City of Corpus Christi

Planning Commission

Wednesday, February 3, 2021

**TECHNICAL REVIEW PLAT REQUIREMENTS
REGULAR PLANNING COMMISSION MEETING
FEBRUARY 3, 2021**

PLAT OF
KING'S LANDING UNIT 2
CORPUS CHRISTI, NUECES COUNTY, TEXAS

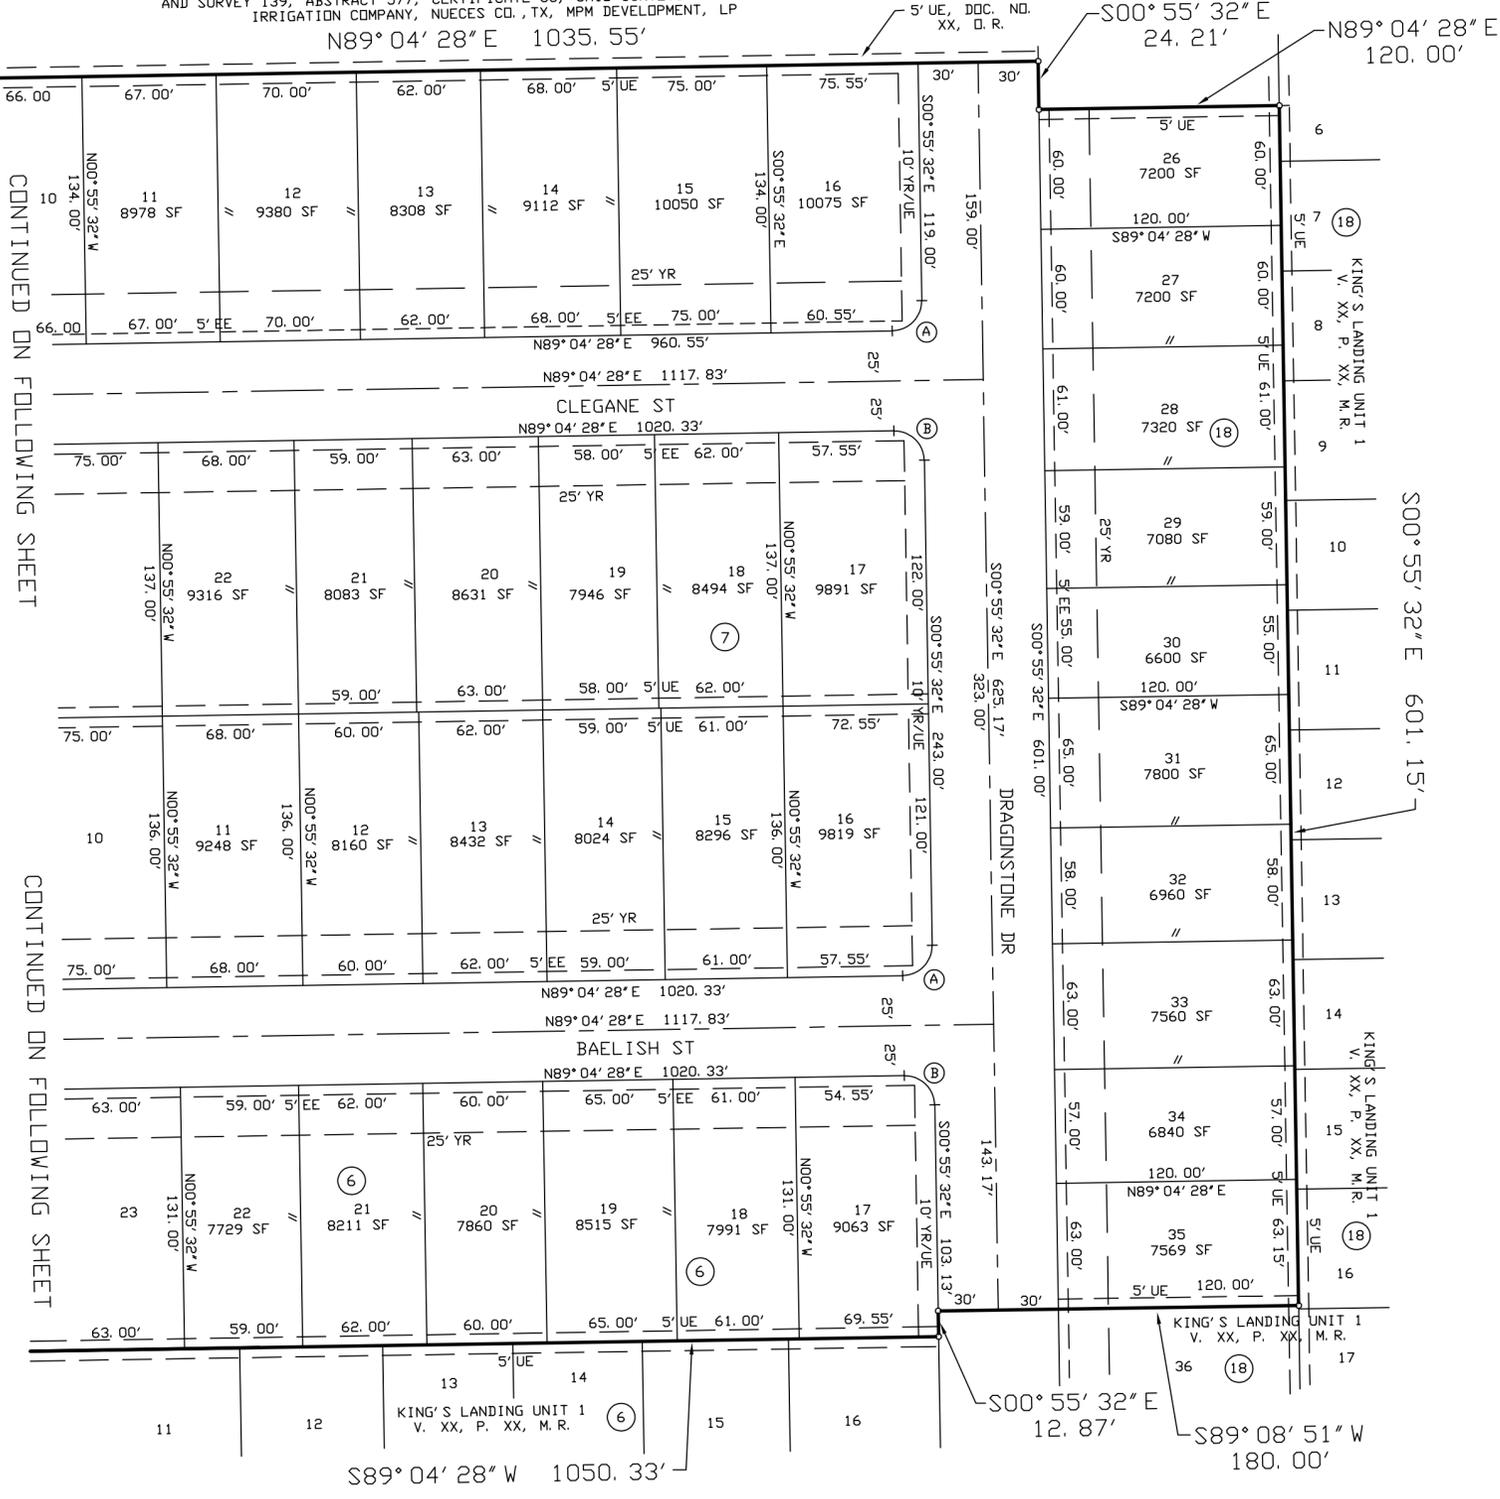
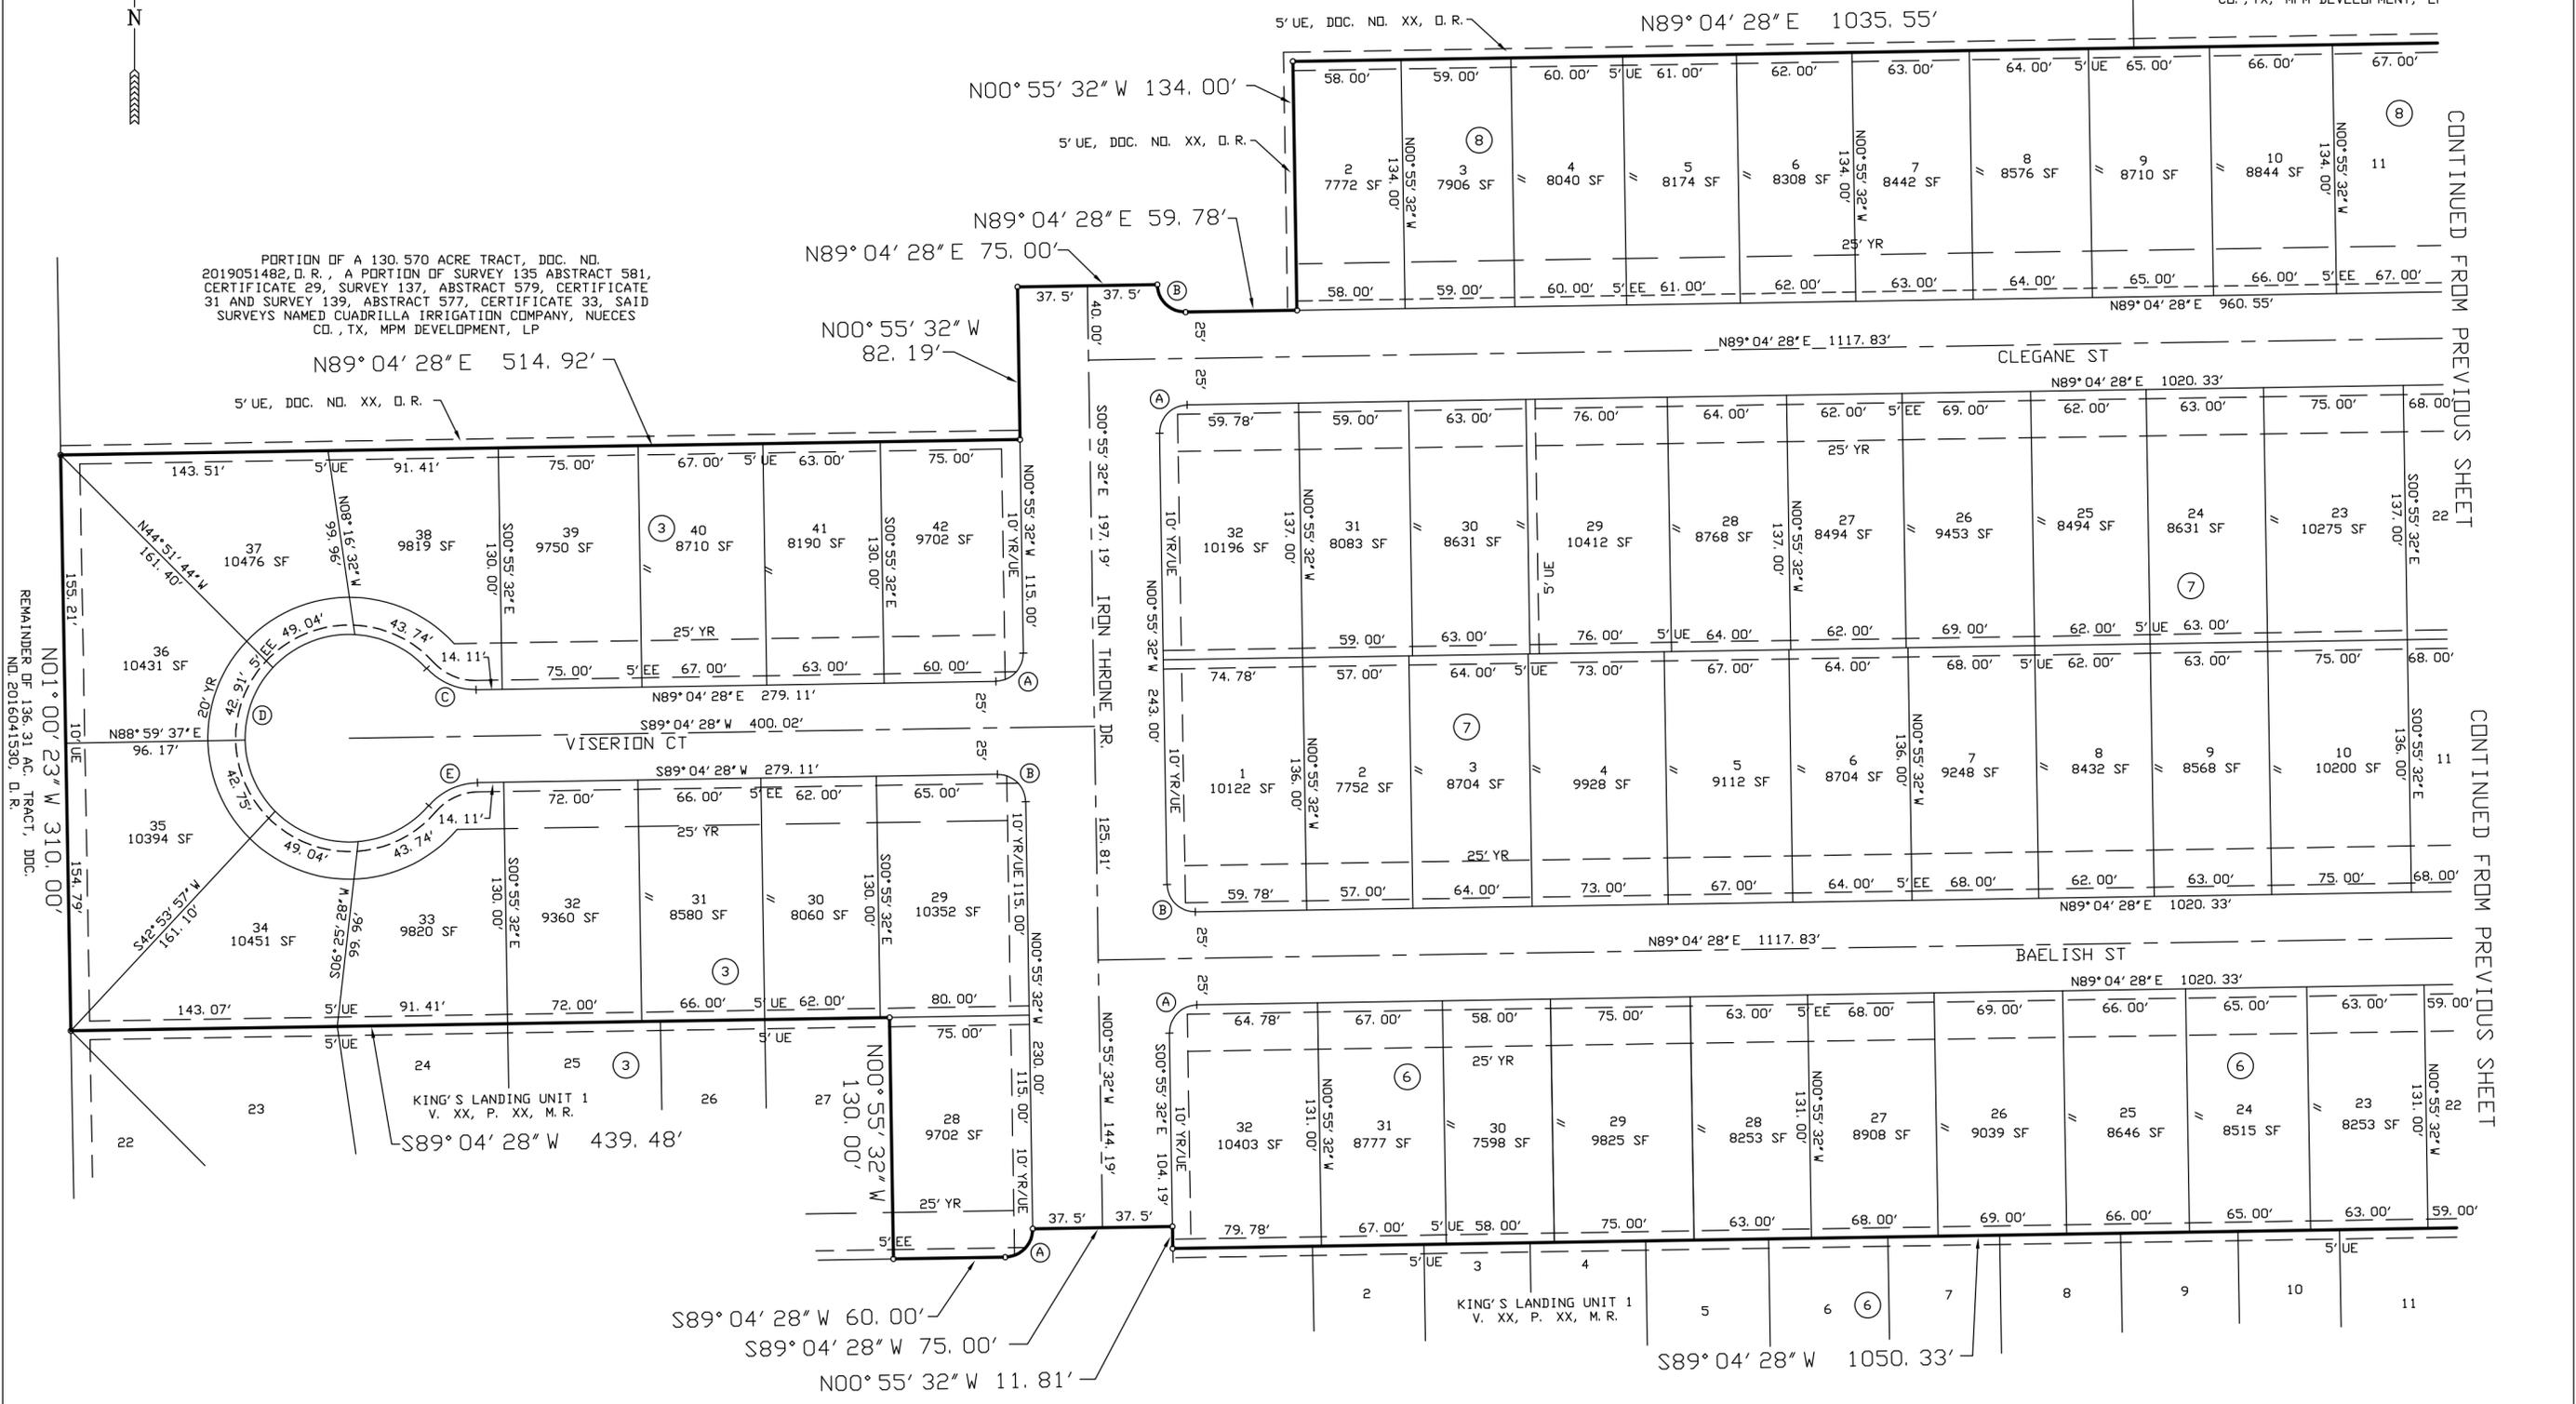
| GIS | | | | | | |
|-----|-------|--|--------------------|------------------|--------------------|------------------|
| 2 | Plat | River Run street name already exists. Please revise street name. | Done. | Resolved. | | |
| 3 | Plat | Please correct duplicate lot number at Lot 16 Block 6. | Done. | Resolved. | | |

| LAND DEVELOPMENT | | | | | | |
|------------------|-------|--|--------------------|---------------------------|--------------------|------------------|
| 2 | Plat | On the Planning Commission certificate block revise "Al Raymond III, AIA" and change "Carl Crull, P.E." to "Jeremy Baugh" | Done. | Addressed | | |
| 3 | Plat | On the Engineering certificate block change "Carl Crull, P.E." to "Jalal Saleh, P.E." | Done. | Addressed | | |
| 4 | Plat | Show and label the continuation of 5.U.E' by separate instrument along the adjacent west property line of Block 8, Lot 2 | Done. | Addressed | | |
| 6 | Plat | Show and label the proposed unrecorded legal description along the south end of Block 18, Lot 36. | Done. | Addressed | | |

| GAS | | | | | | |
|-----|-------|--|--------------------|------------------|--------------------|------------------|
| 1 | Plat | Provide 5' U.E. west side of lot 29, blk. 7 and lot 2, blk. 8 and 5' U.E. south side of lot 35, blk. 18 | Done. | Addressed | | |
| 2 | Plat | Provide 5' U.E. by separate instrument North of lot 26, blk. 18 and 5' U. E. West side of lot 29, blk. 7 | Done. | Addressed | | |
